Subject: Water Pollution Abatement Plan WPAP- Response to questions  
H.L. Zumwalt Construction, Inc. - (CN602748824) (RN105835375)  
FM 1283 Ranch Quarry, Medina County (EAPP ID # 2897.01)

**H.L. Zumwalt Construction, Inc.  
FM 1283 Ranch Quarry**

NAME OF PROJECT: FM 1283 Ranch Quarry; Located on FM 1283 approximately 5 miles west of FM 471 and SH 211, San Antonio ETJ, Texas  
PLAN TYPE: Request for Approval of a Water Pollution Abatement Plan (WPAP); 30 Texas Administration Code (TAC) Chapter 213; Edwards Aquifer Protection Program ID No. 2897.01

**VEHICLE PARKING &  
BASE FUELING PAD  
CALCULATIONS**

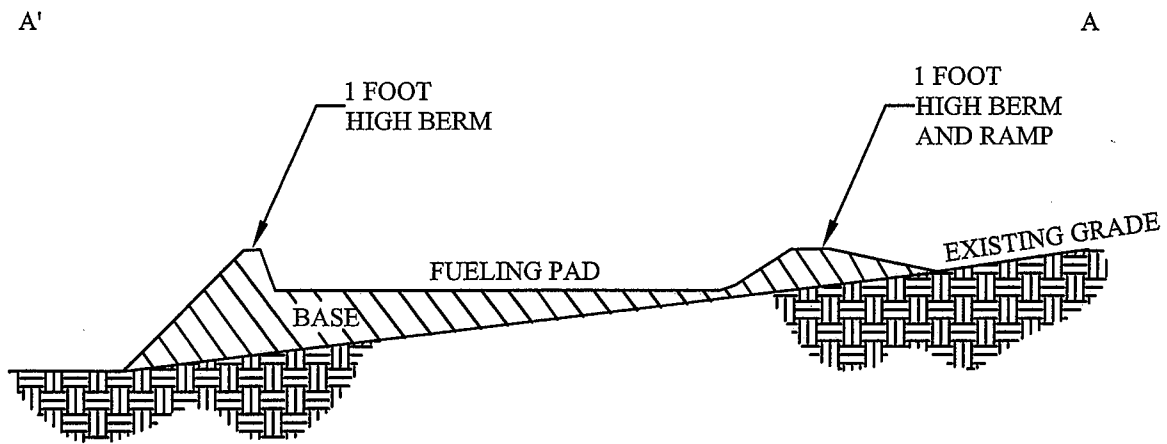
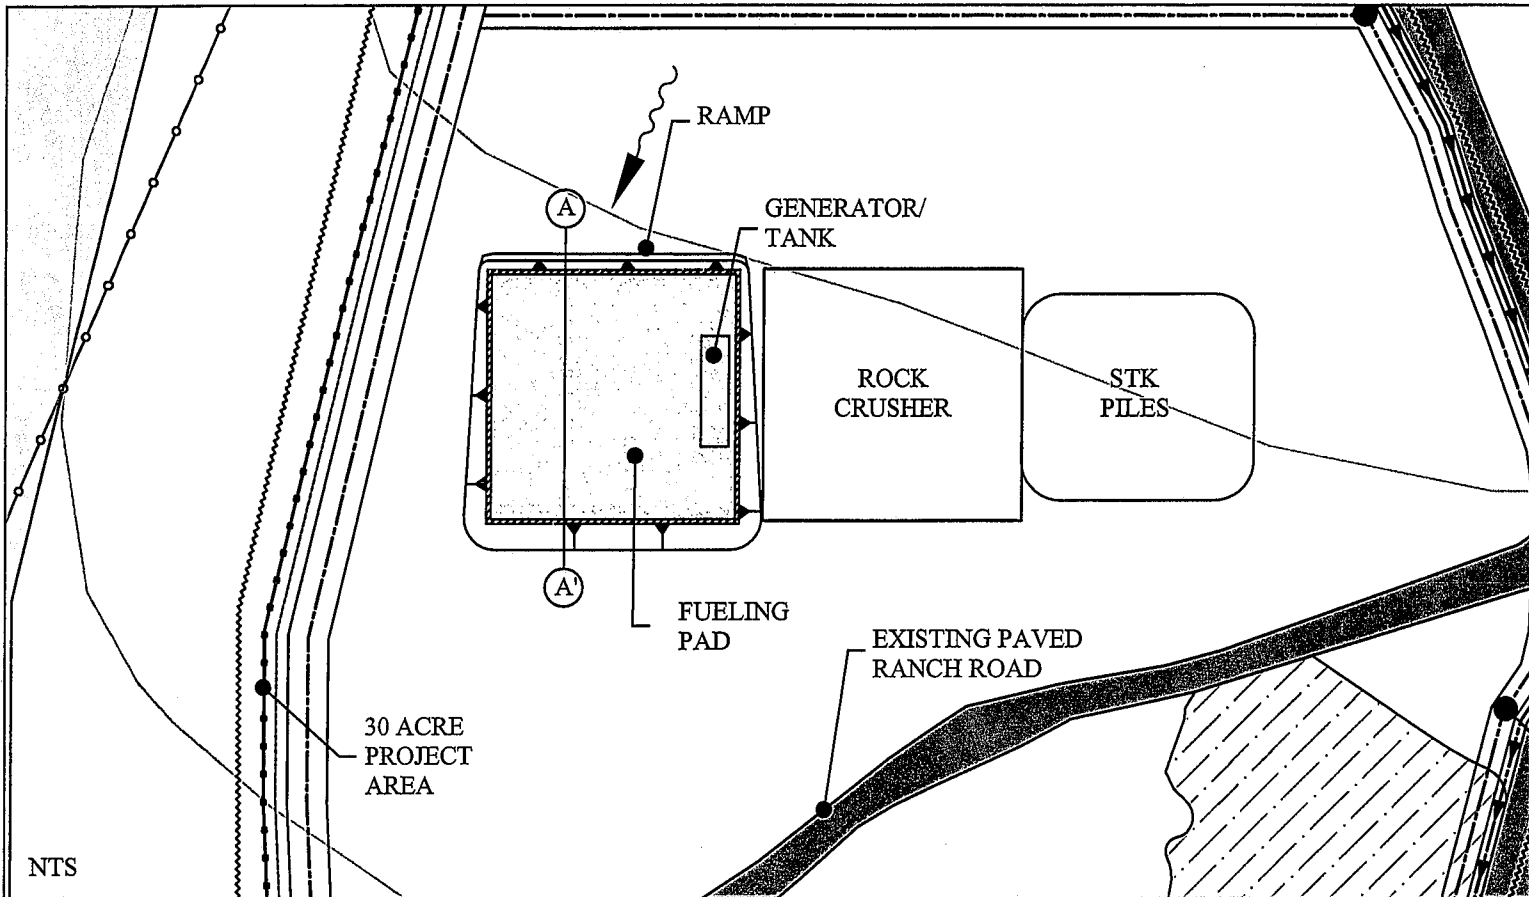
5. Provide a schematic of the fueling pad.
6. Under what conditions will stormwater, which collects in the quarry pit, have to be discharged under the TPDES general permit and what is the process that must be taken to discharge under the permit? The TGM states that "when possible avoid dewatering discharges by using the water for dust control..." Will collected storm water be used for dust control?

Please see the attached schematic of the proposed fueling pad. The fueling pad and generator/tank will always be located outside of the quarry pit. – *Appendix C*

LENGTH OF PAD = 100 FEET  
 WIDTH OF PAD = 100 FEET  
 HEIGHT OF BERM = 1 FOOT

CALCULATED CAPTURE VOLUME = L x W x H

100 FEET x 100 FEET x 1 FOOT = 10,000 FEET<sup>3</sup>  
 10,000 FEET<sup>3</sup> = 74,813 GALLONS
